COPPERSTRING EIS

Attachment F - Vegetation Clearing Works plans

Dajarra Road to Mount Isa

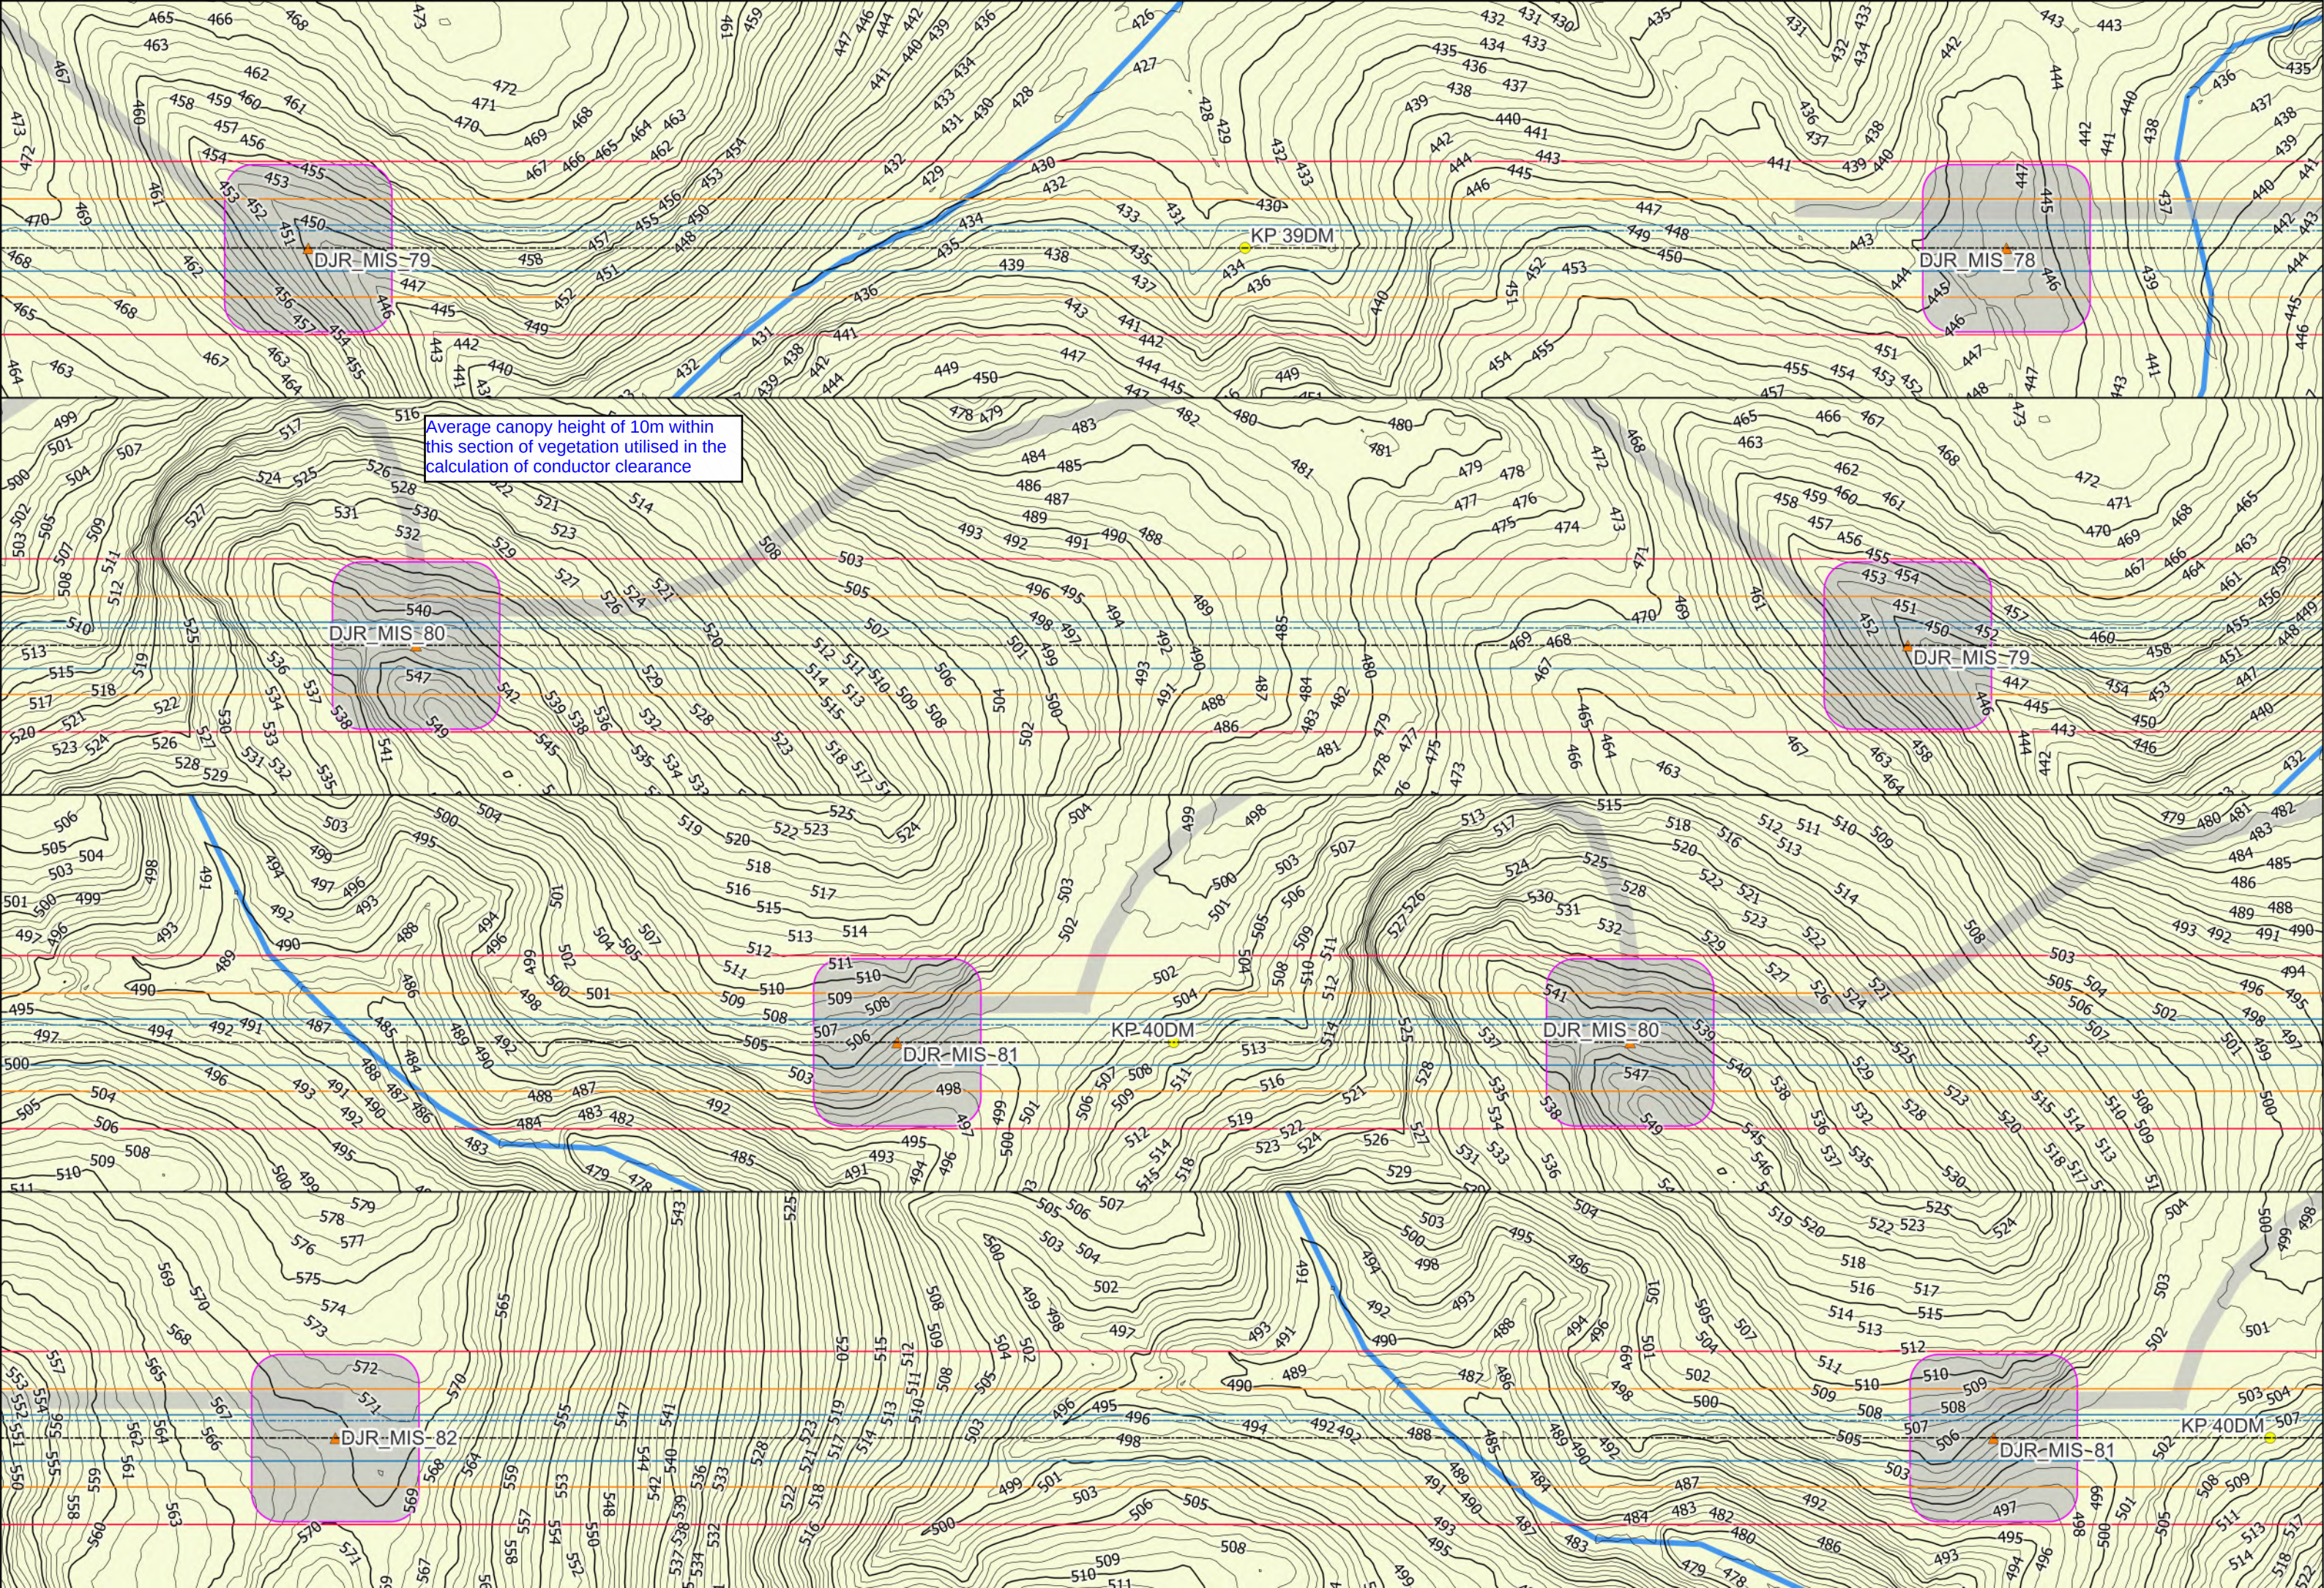
Tower assembly area to be reconfigured to not be within 15m of the high bank of waterway and to avoid clearing near or within the bed and banks for the waterway.

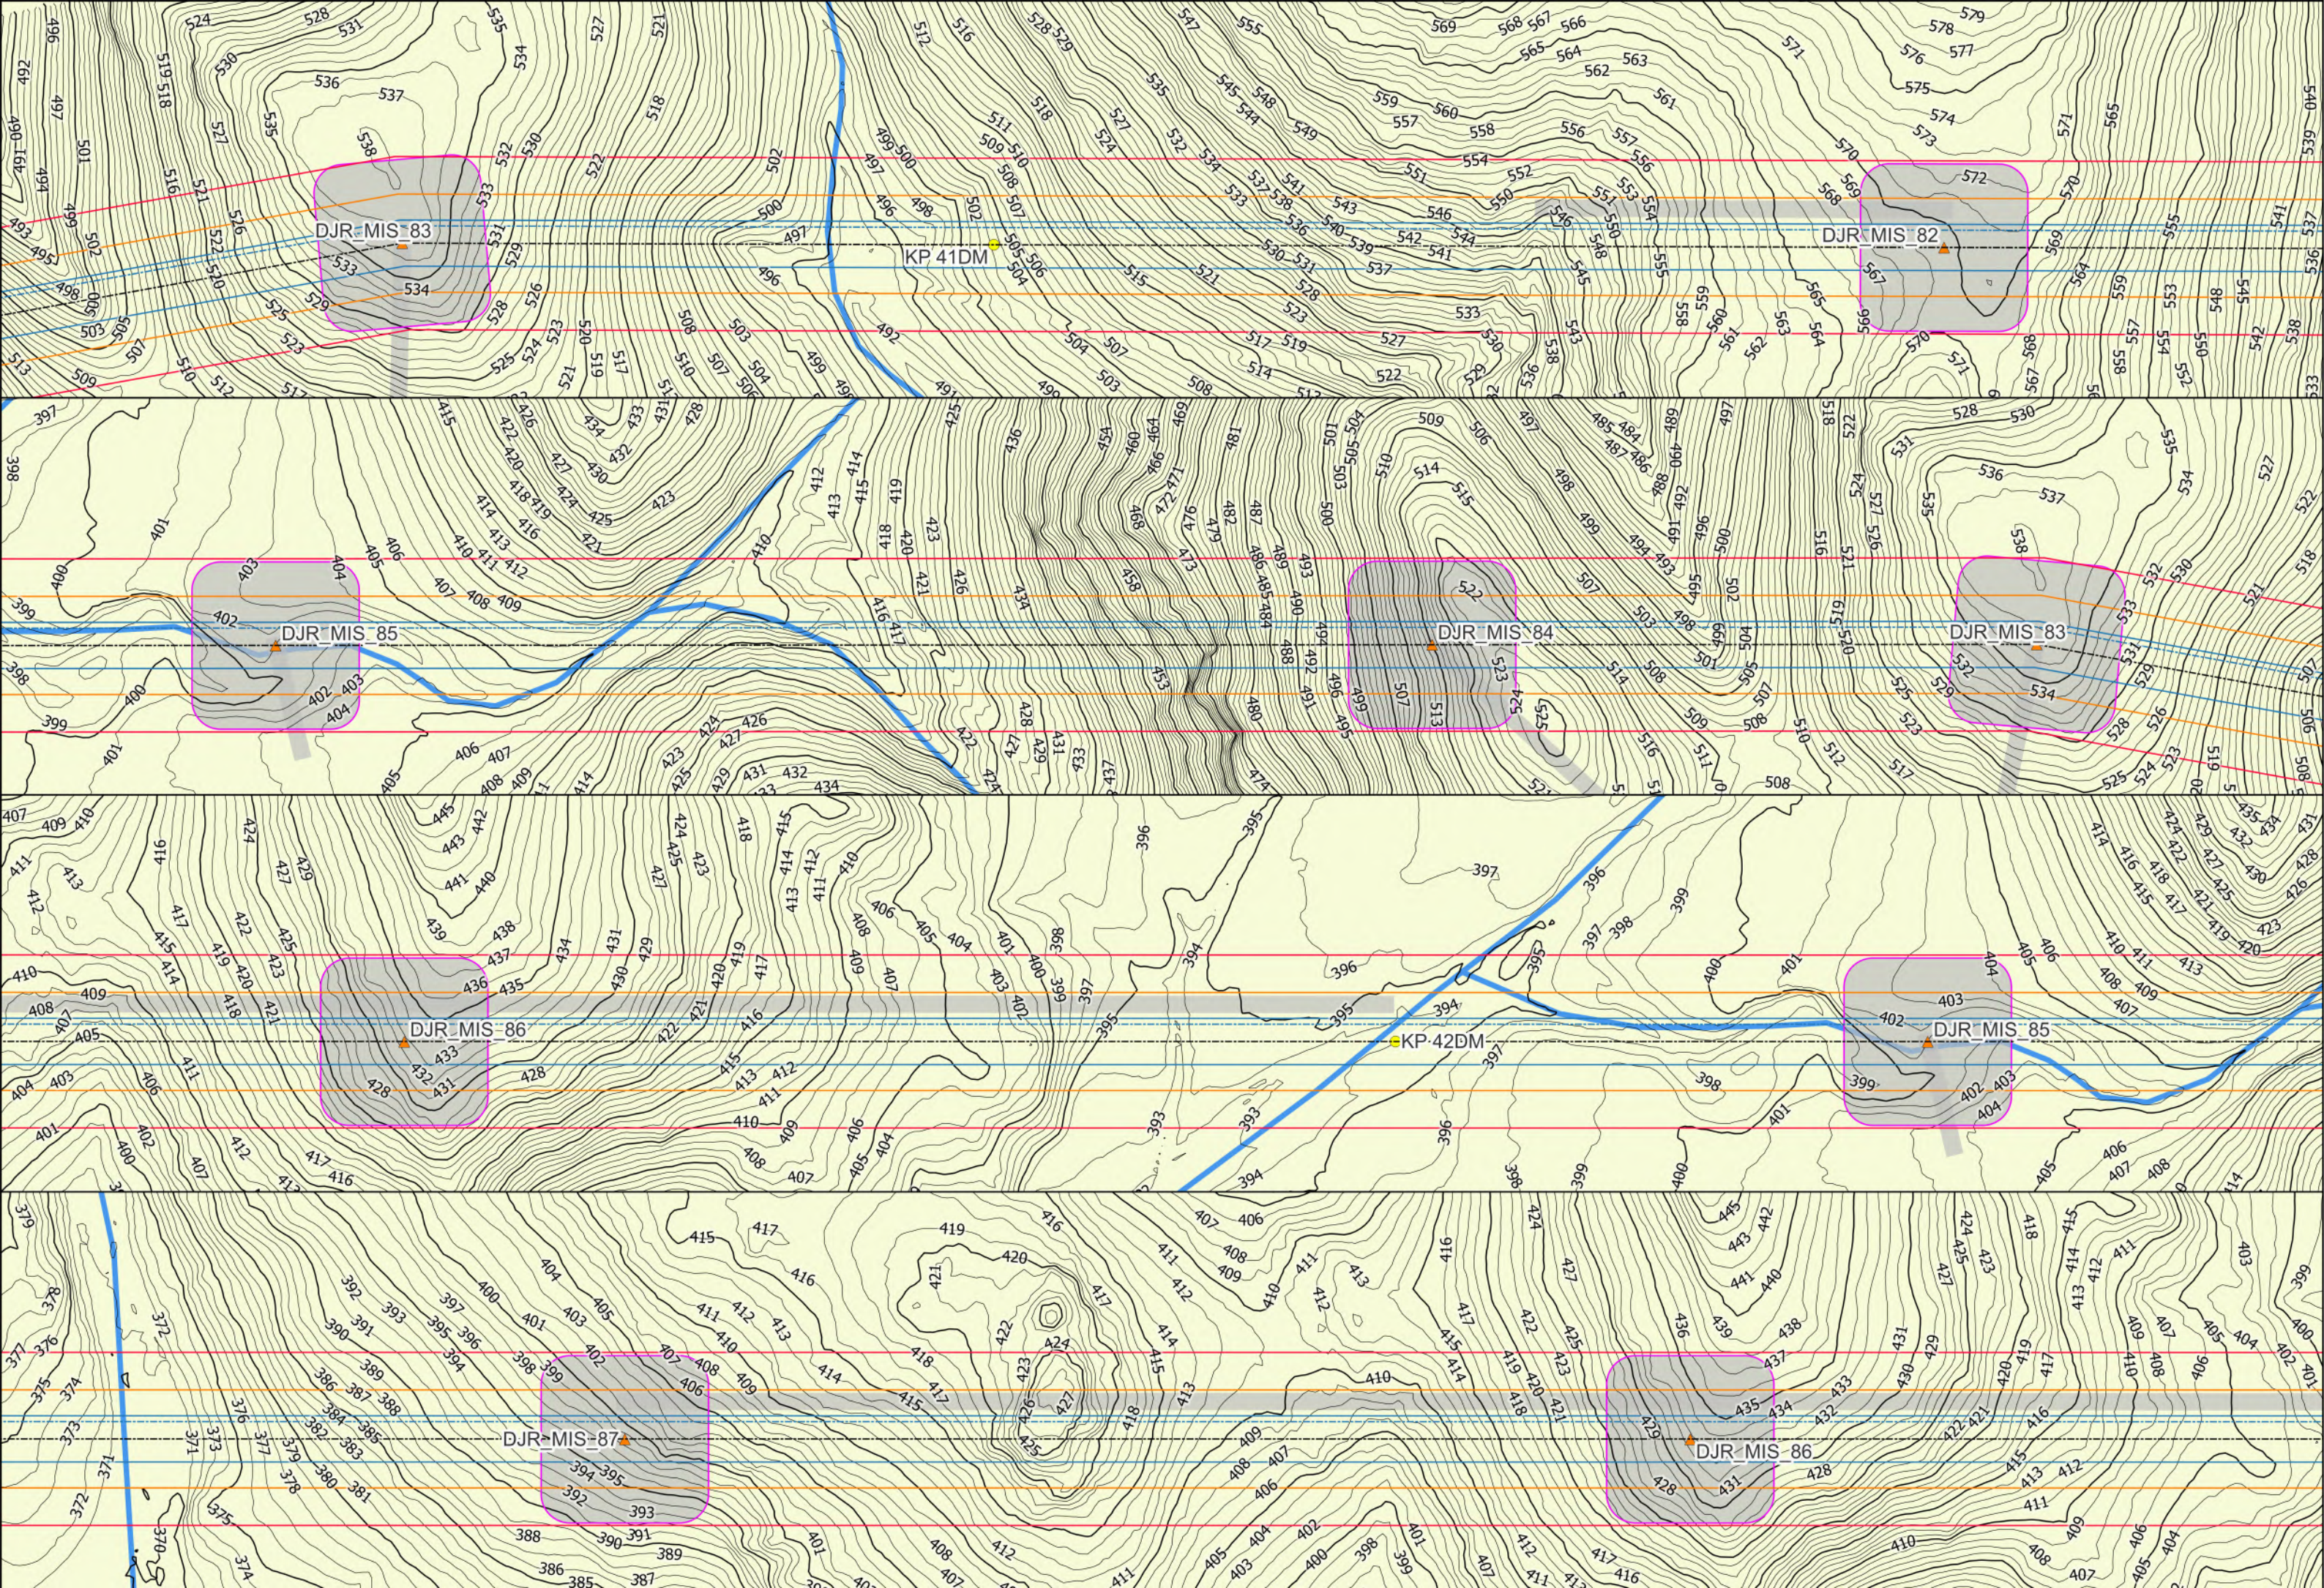
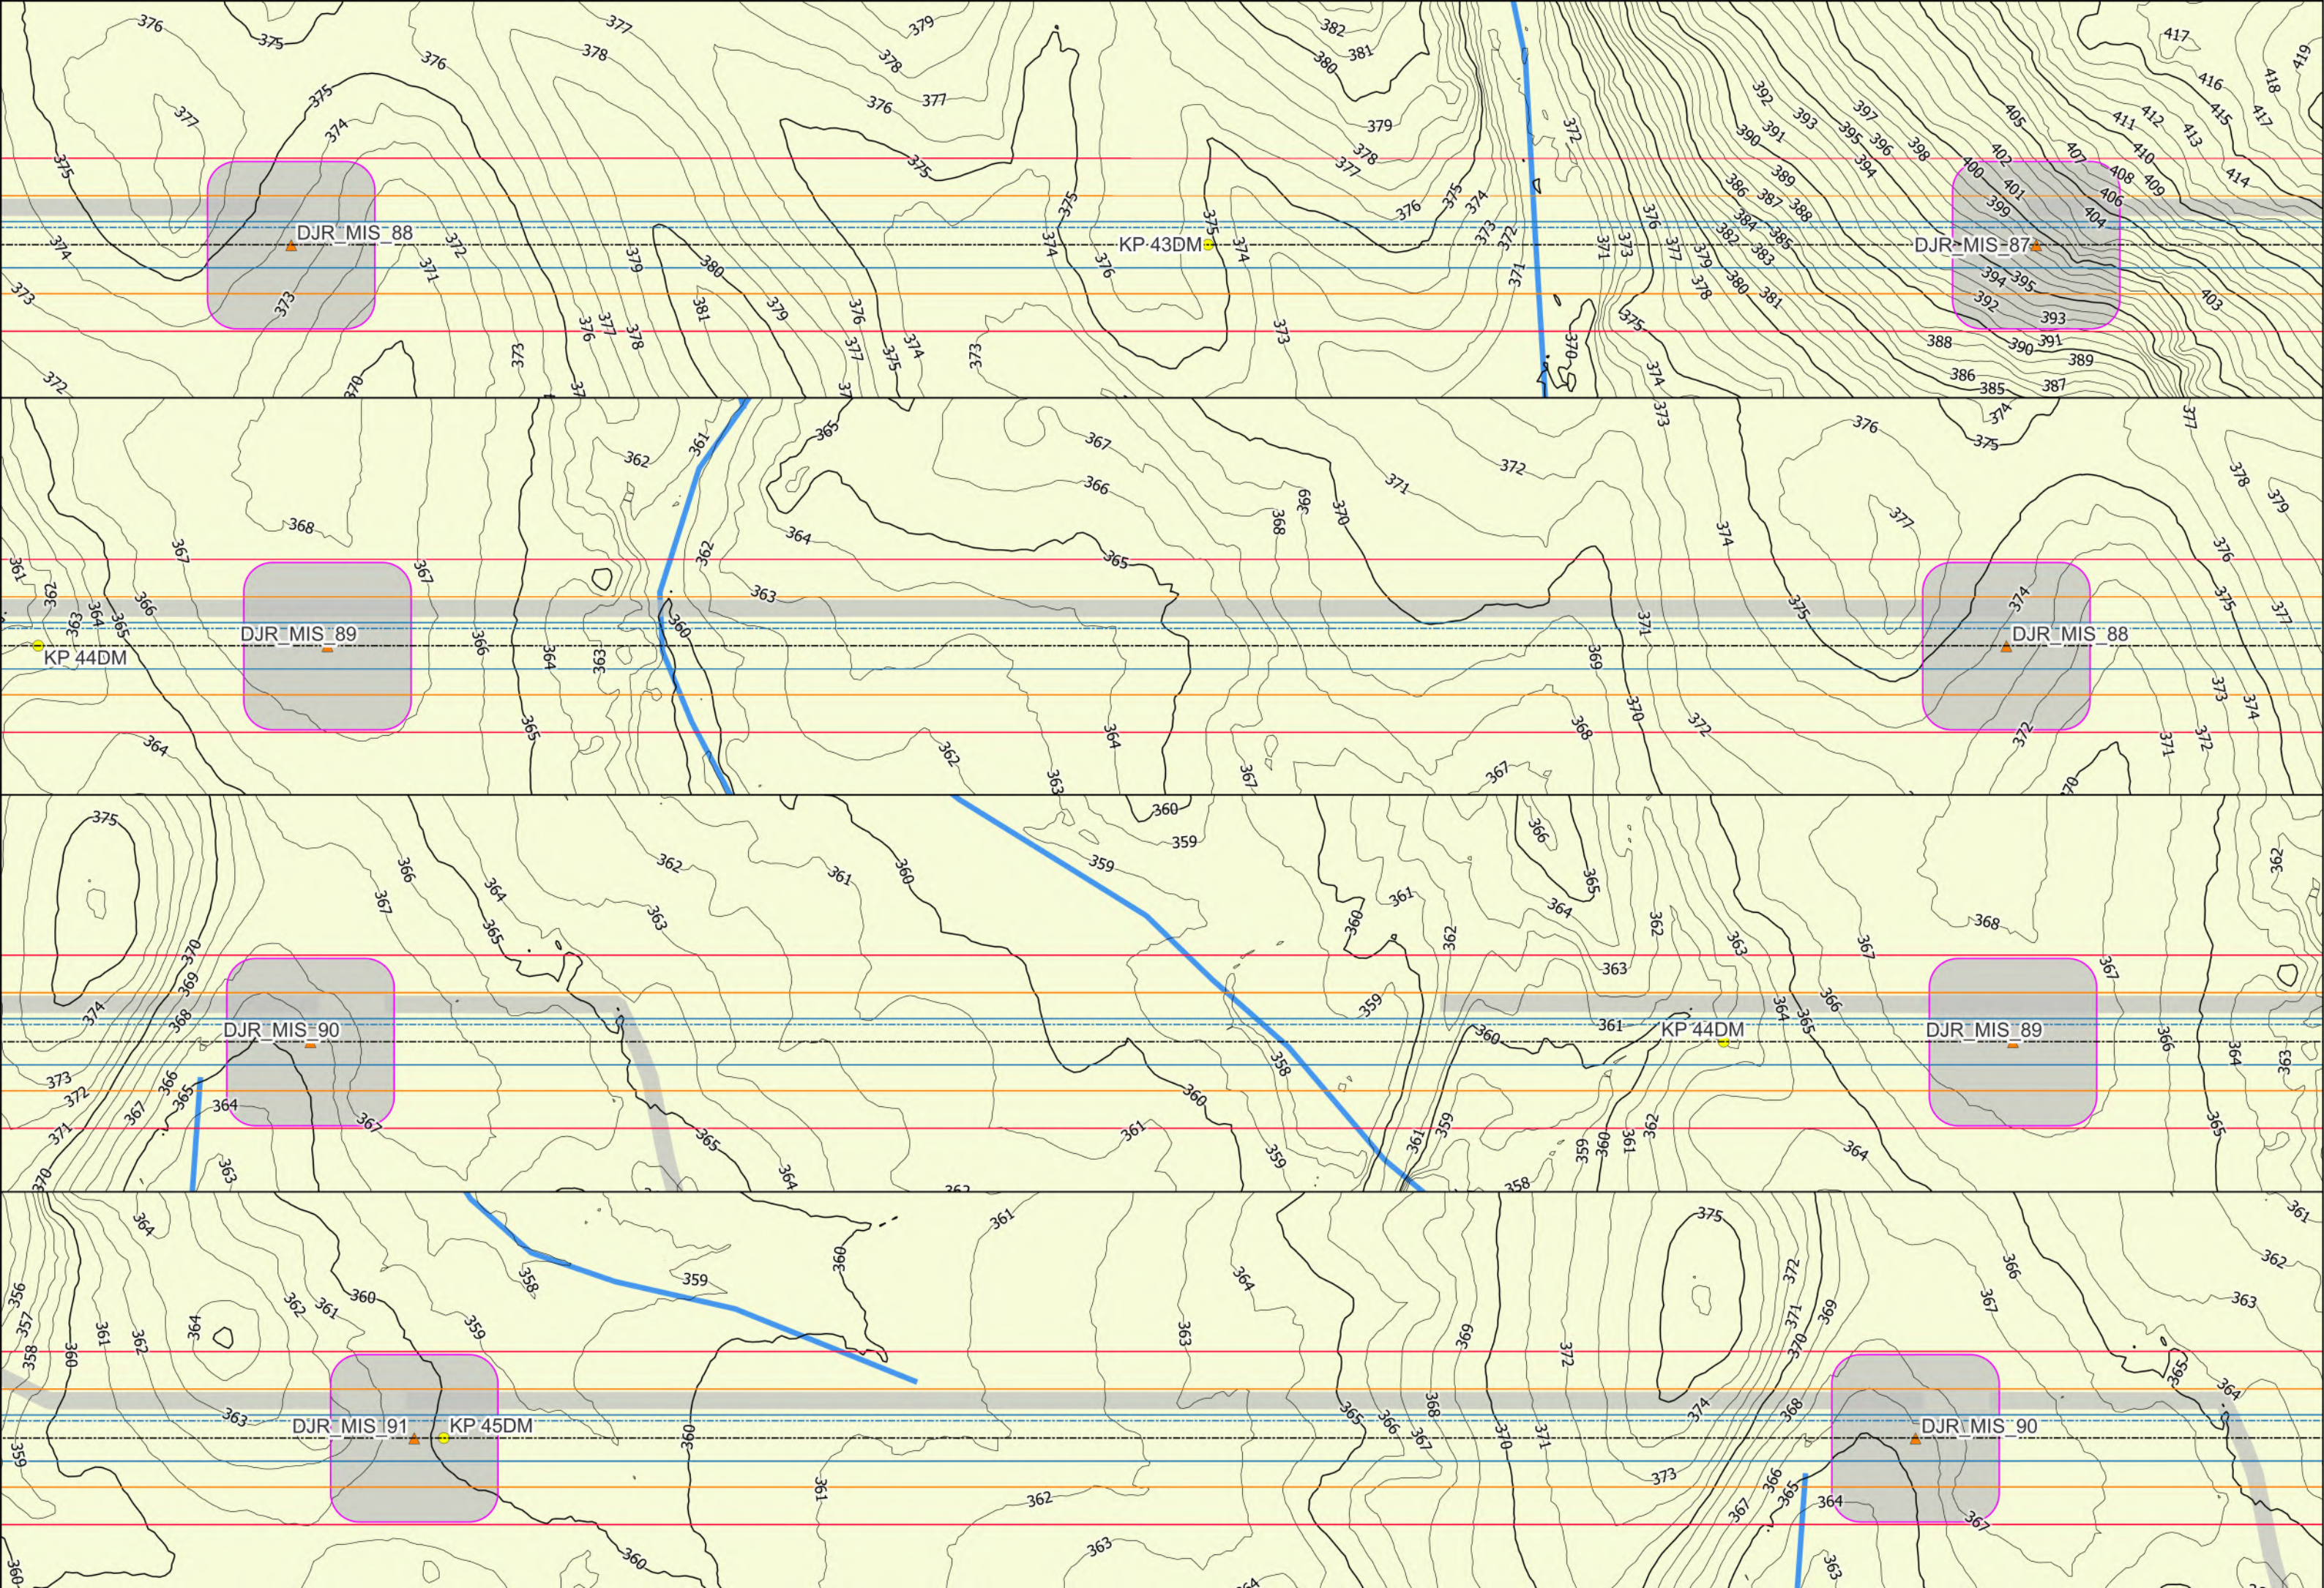
Average canopy height of 10m within this section of vegetation utilised in the calculation of conductor clearance
